Access Compliance Report

Public Rights-of-Way

Intersection ID: 14383	Main Street: CLEVELAND_AV	Cross Street: E TREMONT AV	Location:	N
ADA ID: 67F50B248BED	Ramp Type: Perp	Initial Pass/Fail: Fail	Overall Compliance: No	Severity Score: 13.75
Codes/Mitigation Info/Possible Solution		Field Measurements/Component Compliance

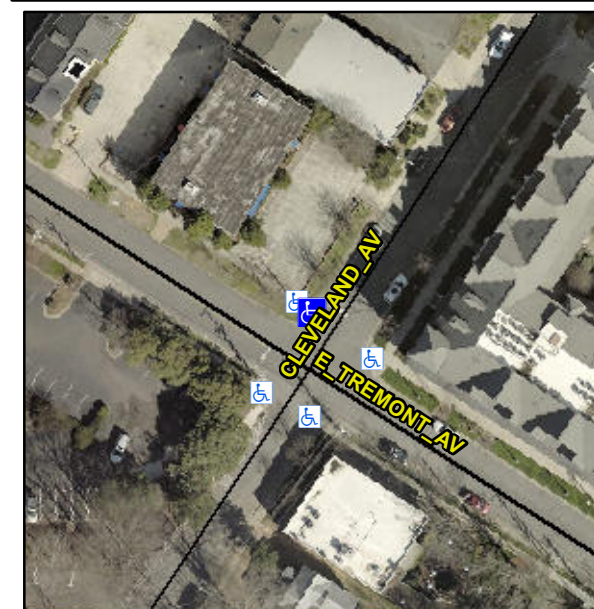
Not Found, R304.2.2, R304.5.3

Compliance	Description	Data	Compliance	Description	Data
N/A	Ramp Length (in)	66.0	No	Ramp Slope (%)	9.6
Yes	Ramp Width (in)	48.0	No	Ramp XSlope (%)	3.4
N/A	Flare Type LT	N/A	N/A	Flare Type RT	N/A
N/A	Flare Slope LT (%)	N/A	N/A	Flare Slope RT (%)	N/A
N/A	Flare Traversable LT?	N/A	N/A	Flare Traversable RT?	N/A
N/A	Landing Length (in)	N/A	N/A	DWS Provided?	N/A
N/A	Landing Width (in)	N/A	N/A	DWS Contrast?	N/A
N/A	Landing Slope (%)	N/A	N/A	DWS Length (in)	N/A
N/A	Landing X Slope (%)	N/A	N/A	DWS Full Width?	N/A
N/A	Landing Curb? (Y/N)	N/A	N/A	DWS Offset (in)	N/A
N/A	Shared Landing?	N/A			
N/A	Gutter Ponding?	N/A	N/A	Gutter Slope (%)	N/A
N/A	Gutter Lip Ht (in)	1.0	N/A	Gutter X Slope (%)	N/A
N/A	Painted X Walk1?	No	N/A	Painted X Walk2?	N/A
	X Walk 1 Direction	To SE		X Walk 2 Direction	N/A
N/A	X Walk 1 Width (in)	N/A	N/A	X Walk 2 Width (in)	N/A
	X Walk 1 Slope (%)	1.5		X Walk 2 Slope (%)	N/A
	X Walk 1 X Slope (%)	2.8		X Walk 2 X Slope (%)	N/A

Remove & Replace Entire Ramp.
